HI-STORE

Chapter 2 & Environmental Report RSIs

• Purpose and Discussion

Site Characterization - Phase 1 Holtec HI-STORE CISF Lea County, New Mexico	Project 1703345	PROPOSED BORING LOCATIONS
Holtec International Camden, New Jersey

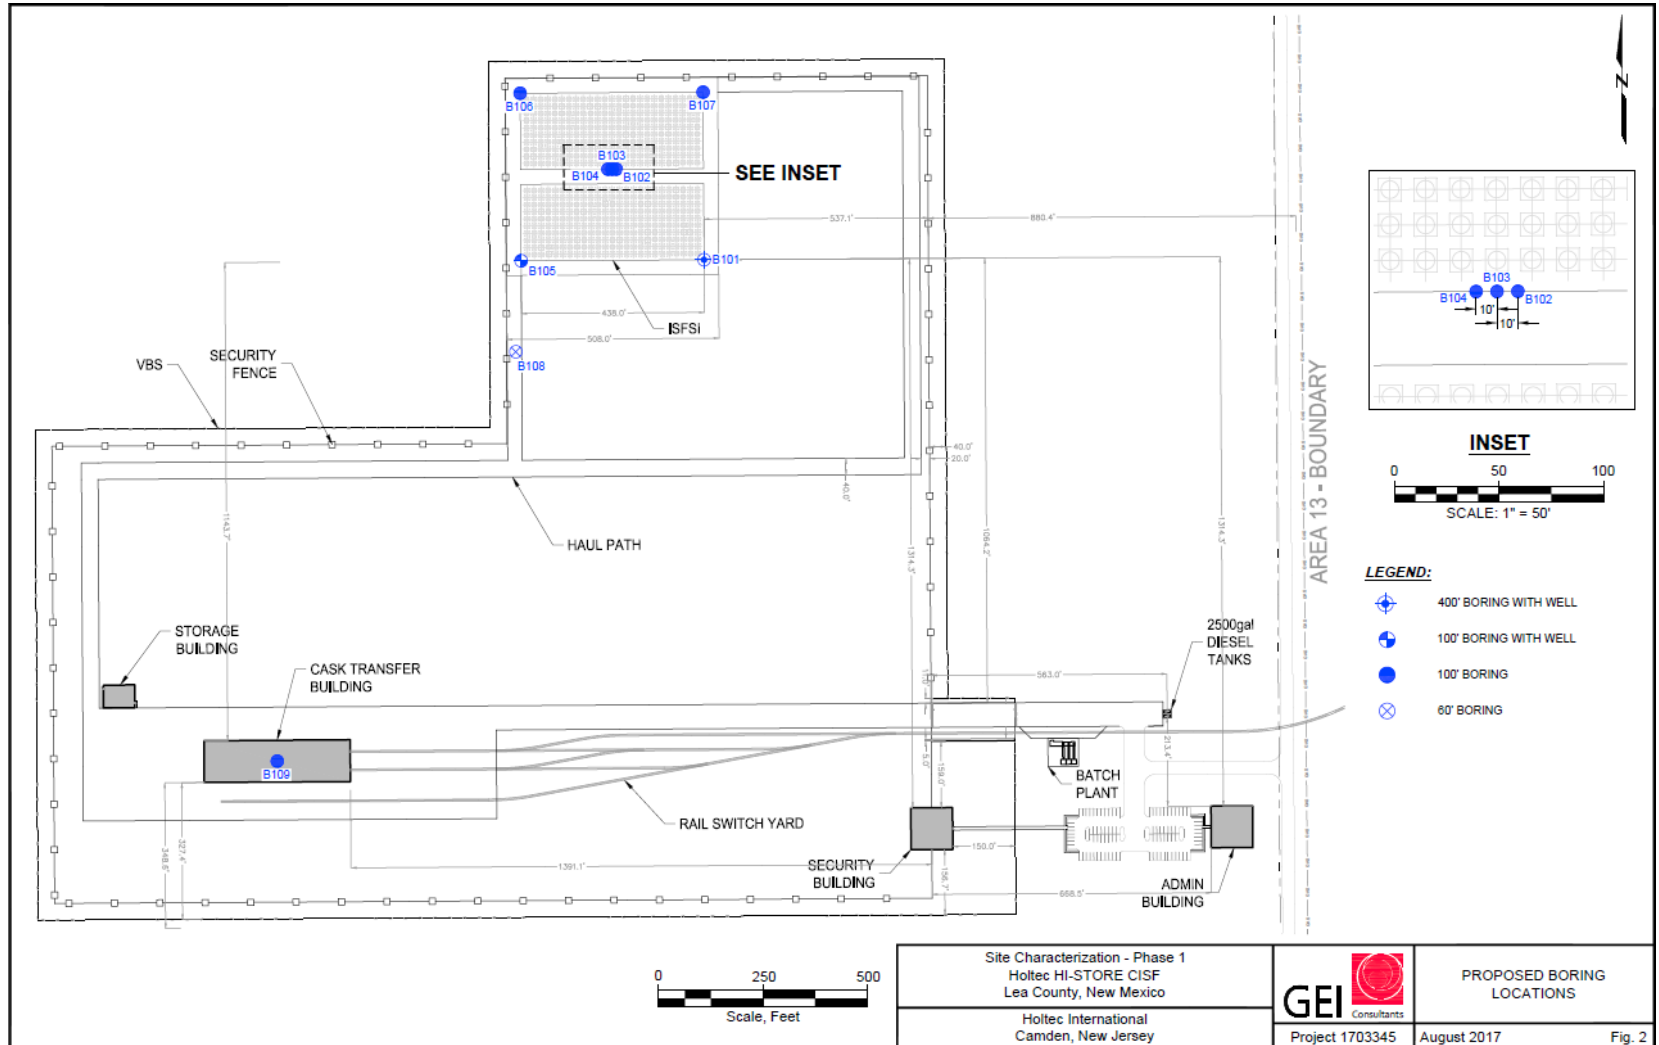
- Requested information includes:
 - Detailed characterization of site subsurface material
 - map of geotechnical exploration
 - Geological profiles
 - Groundwater mapping

- Strategies to respond
 - Boring plan generated using standard Holtec protocol
 - Protocol has been used at many other ISFSI sites (SONGS, BFN, CPS, WBN, Etc.)
 - 9 Standard Penetration Test (SPT) Borings
 - Cross-Hole Seismic Test
 - NUREG-1567 required laboratory testing
 - Groundwater observation wells
 - NUREG-0800 Section 3.2.7 COV values taken as 1
